Land West of Market St, Edenfield (H66)  
Amended Masterplan submitted in September 2023

**Responses Received**

H66 Masterplan (Taylor Wimpey, 2023)

**Figure 1:** Extract from Applicant's Parking Beat Survey Data

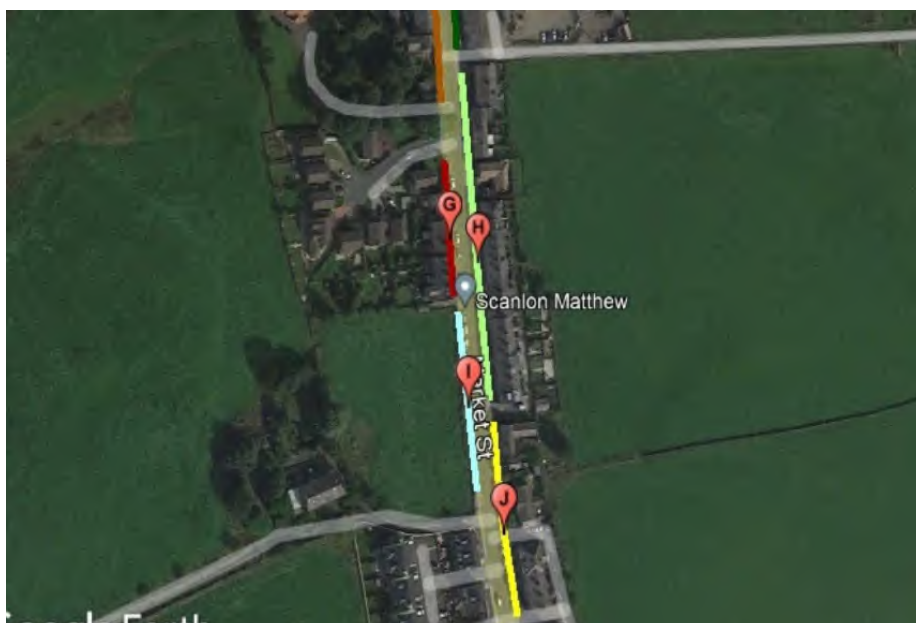
This equates to a total of 39 parked vehicles parked on-street in the immediate vicinity of the proposed main site entrance on Market Street. Applying a 6m bay space length would mean 234m of kerbside parking would be required in this location to accommodate this parking demand.

Drawing 3806-F04 H shows a formalised parking bay on the eastern side of Market Street, from No.102 to 136a. This bay measures circa 86m in length. Further south an additional bay measuring 30m is provided in front of nos. 76 to 82 Market Street. Even with this combined kerbside parking this only equates to parking for circa 19 cars, a shortfall of 20 parking spaces against the existing parking demand on this short section of Market Street.

Figure 2: Extract from Applicant's Corridor Improvement Strategy

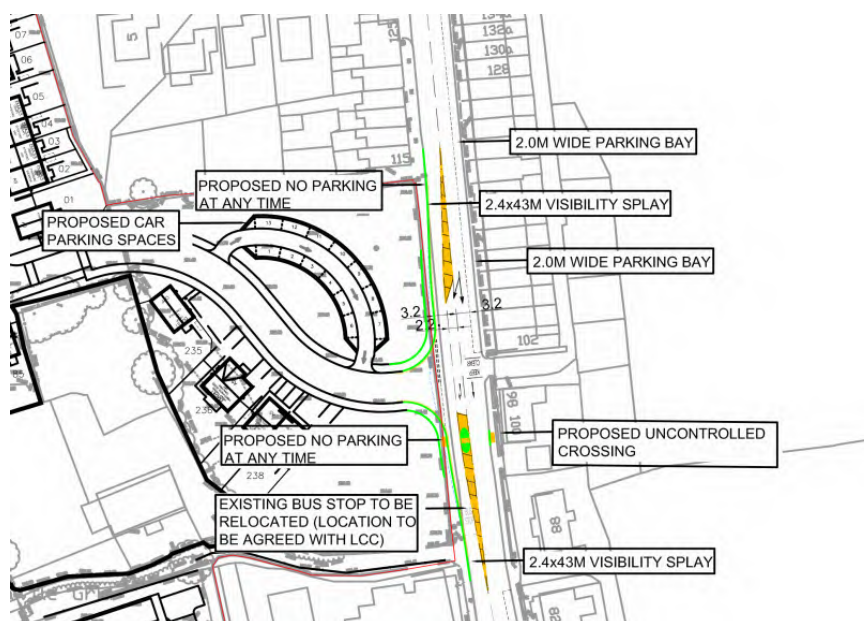
As shown in **figure 2** below the proposed design does not meet the design requirements set out above for the width of the ghosted right turn lane. Paragraph 6.10 confirms 3m is the minimum width for a new junction, and is required to ensure a motorist can safely wait whilst turning right clear of oncoming traffic and to avoid vehicles blocking southbound ahead movements.

A 2.2m wide right turn pocket does not meet the requirements of CD123. It is 0.8m narrower than the minimum 3m wide pocket for a new junction.

In addition, with the access proposals not delivering a 2m wide footway on the eastern side of Market Street, the design as proposed cannot be considered appropriate to serve a new residential development of any scale.
